**PARK CITY MUNICIPAL CORPORATION
PLANNING COMMISSION
CITY COUNCIL CHAMBERS
January 10, 2018**

Planning Commission Staff Report

Subject: 88 King Road Avenue
Project #: PL-17-03618
Author: Hannah M. Tyler, Planner
Date: January 10, 2018
Type of Item: Administrative – Steep Slope Conditional Use Permit

SITE
GRADING
PLAN
SCALE:
1" = 10'

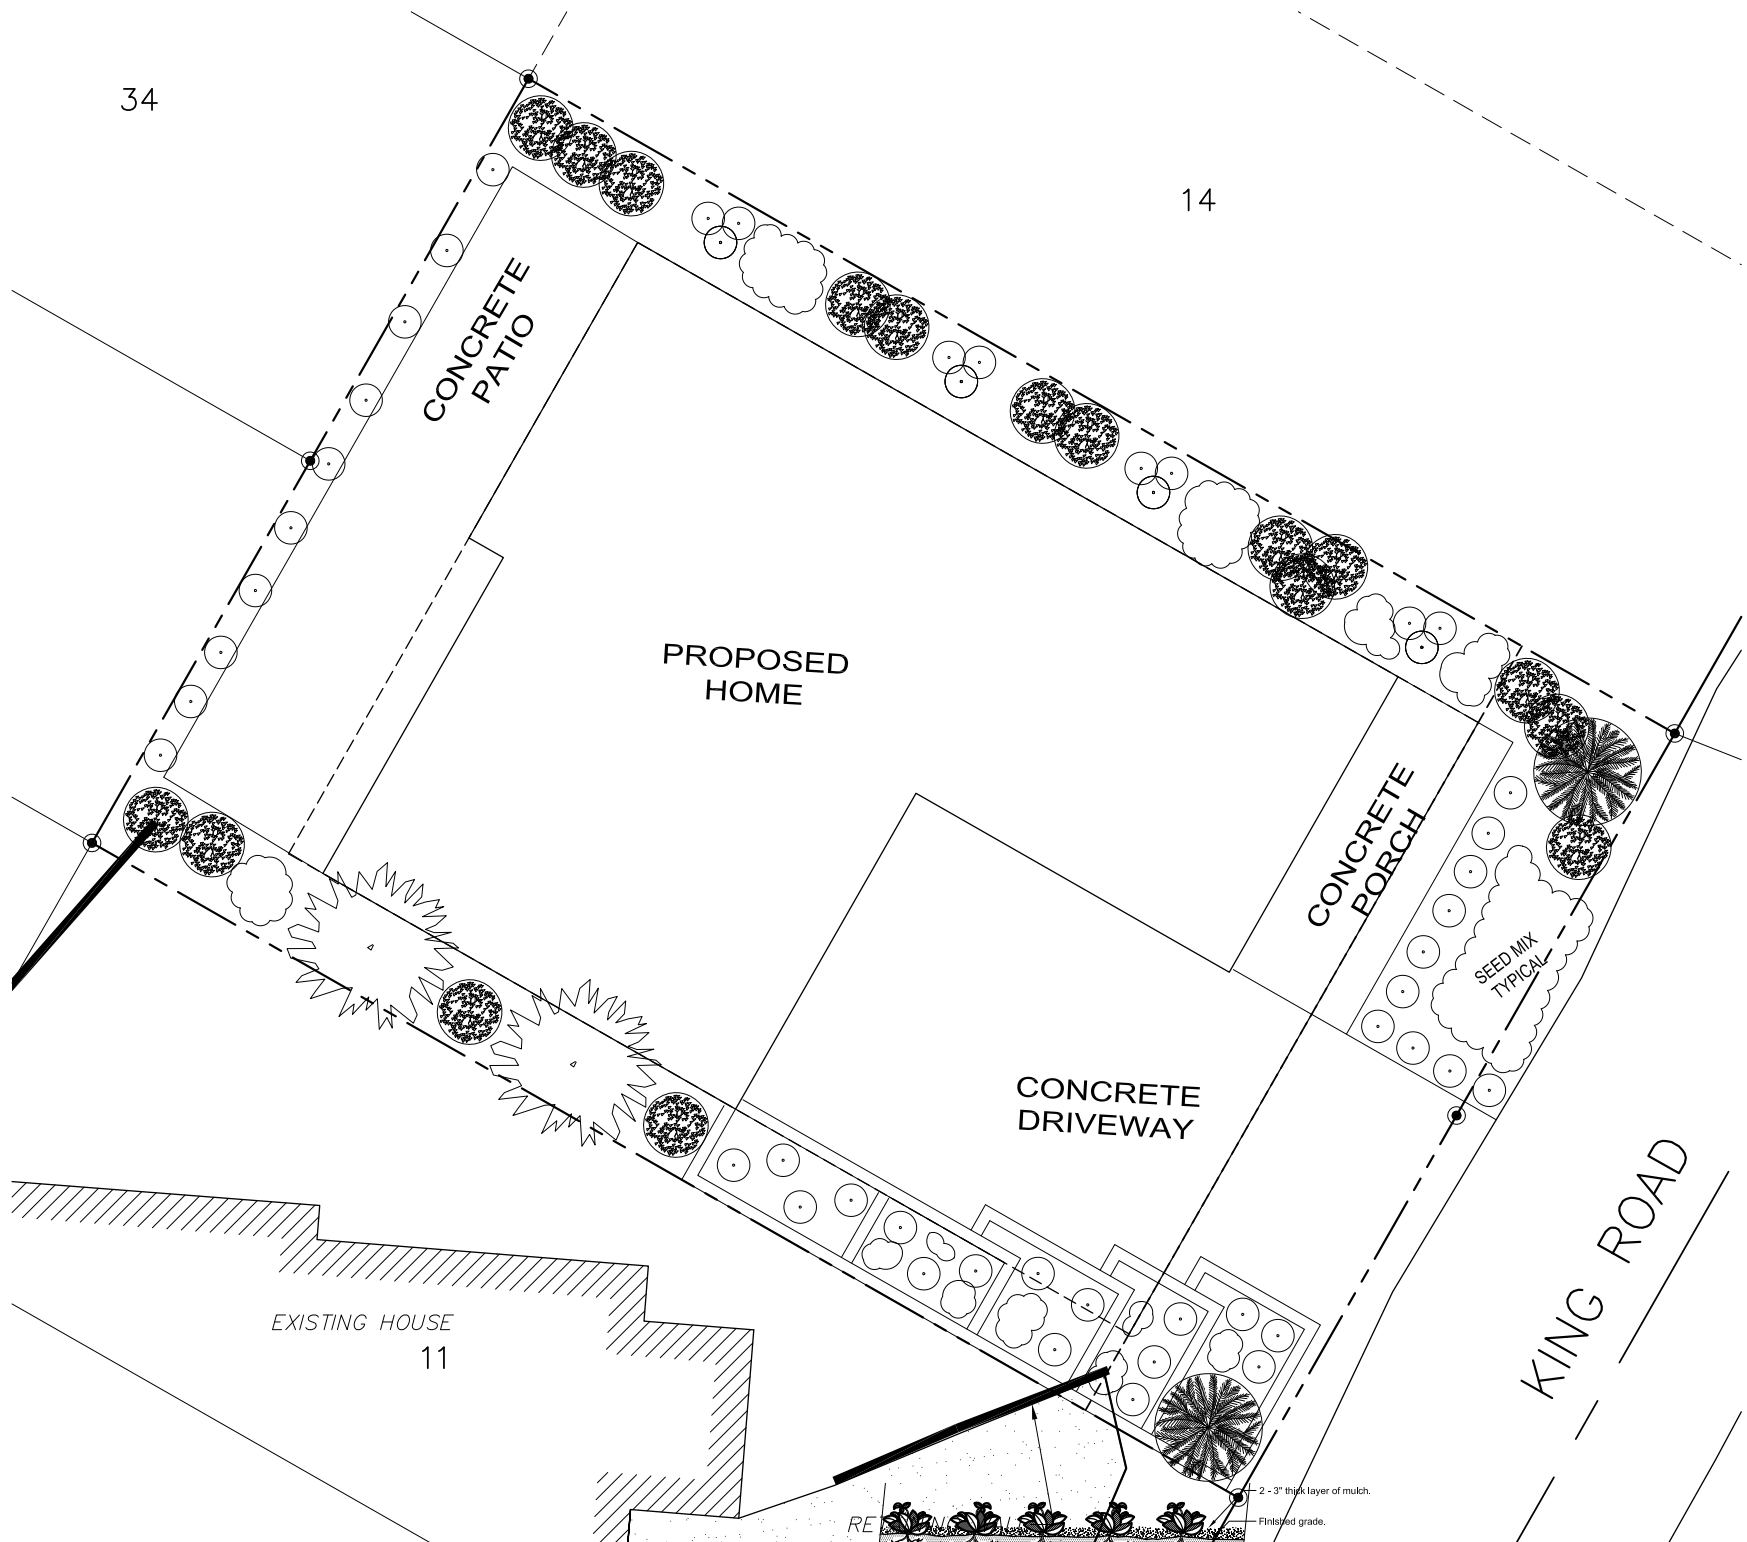
The proposed driveway leads to two (2) single-car garages. As stated previously, the applicant has incorporated terraced retaining walls which mitigate the visual impact of the steep grade. The terraces will not change grade by more than 4 feet and occur within the property. These terraced retaining walls mitigated the need for a large and out of scale retaining wall to accommodate the garage(s) entrance.

There are also retaining walls in the rear yard to accommodate a patio area. The retaining walls throughout the site will not change grade more than 4 feet from Existing Grade. The applicant will change grade at the garage entrance which is allowed per LMC 15-2.1-5 Building Height.

① Streetscape Elevation
1/8" = 1'-0"

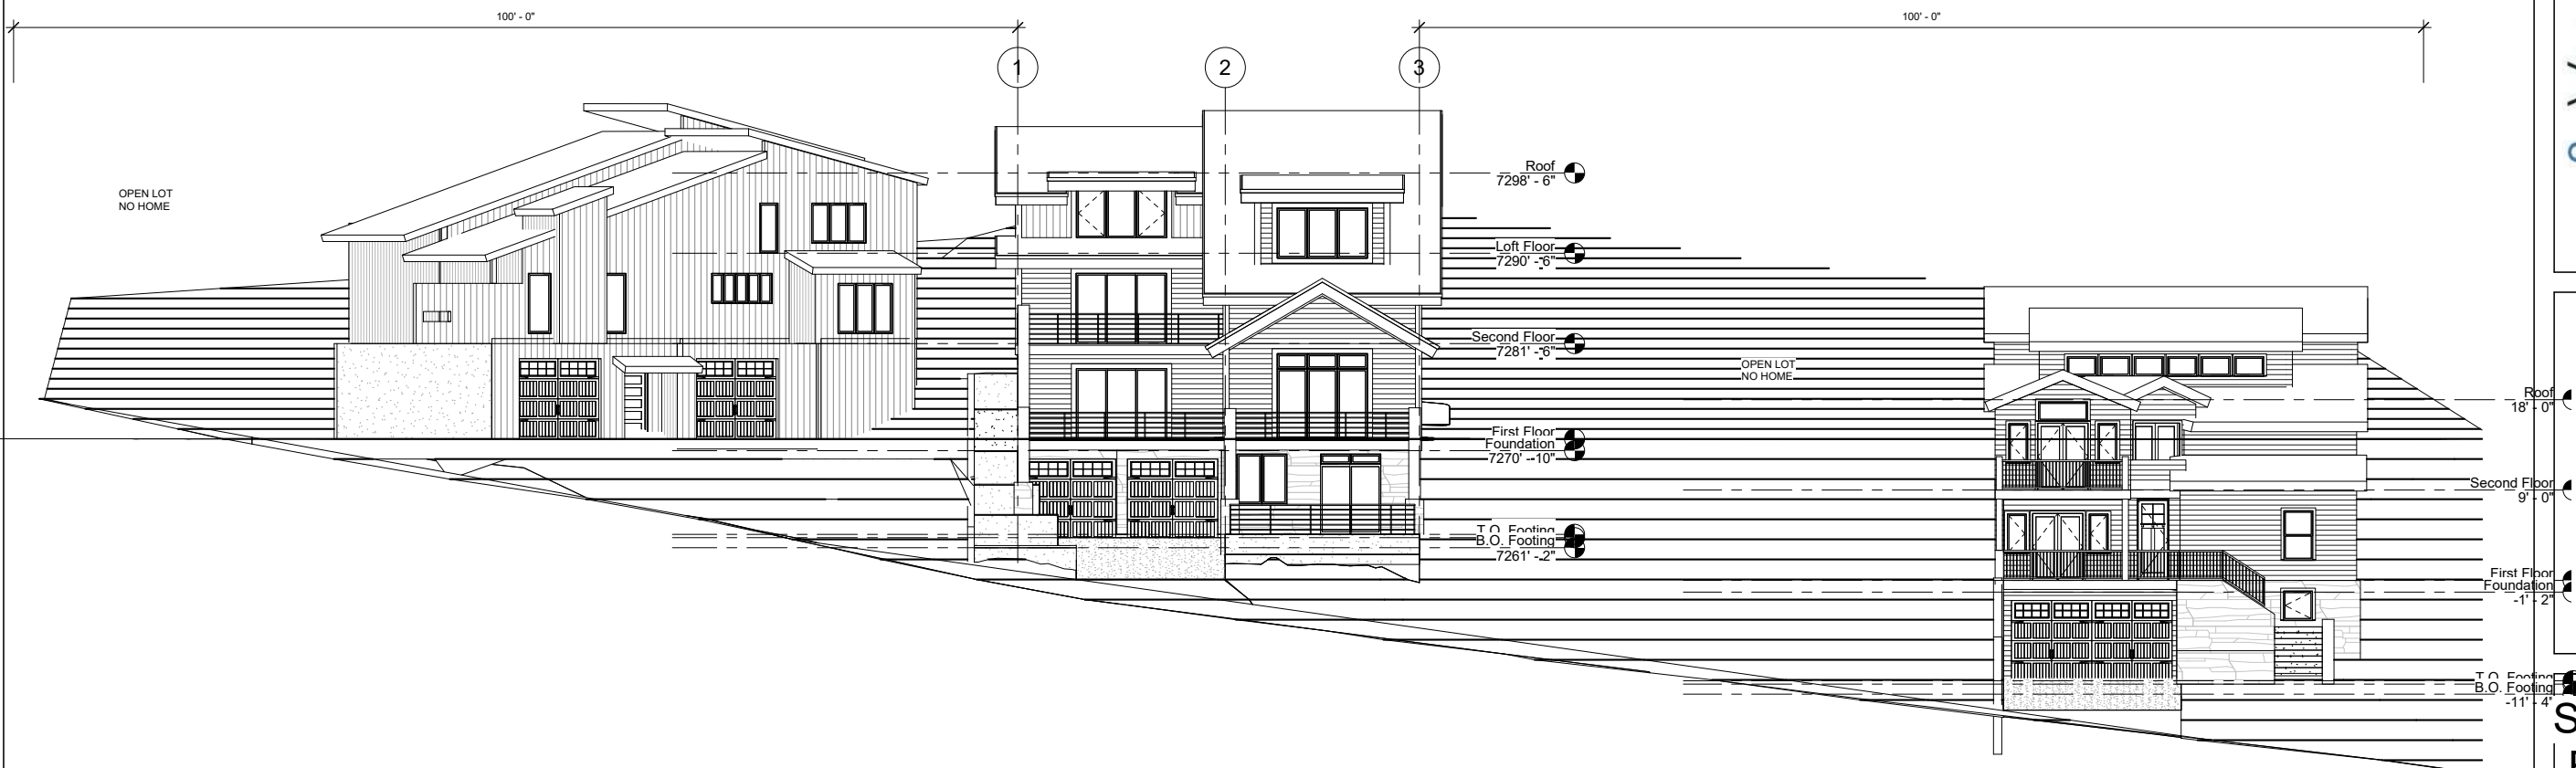
The applicant submitted a photographic visual analysis, including street views, to show the proposed streetscape and cross canyon views. As demonstrated by the visual analysis, the proposed new single-family dwelling fits within the context of the slope, neighboring structures, and existing vegetation. The neighborhood consists of historic houses with one- to two-story additions, one- to two-story new houses, and a few three- to four-story new residential developments.

The visual analysis, streetscape, and cross canyon view demonstrate that the proposed design is visually compatible with the neighborhood, similar in scale and mass to surrounding structures, and visual impacts are mitigated. By stepping the structure up the hill, the mass and scale have been broken up and largely minimized. The side yard will be re-vegetated following construction. The terraced retaining walls mitigate the visual impact of the steep grade. The terraces will not change grade by more than 4 feet and occur within the property.
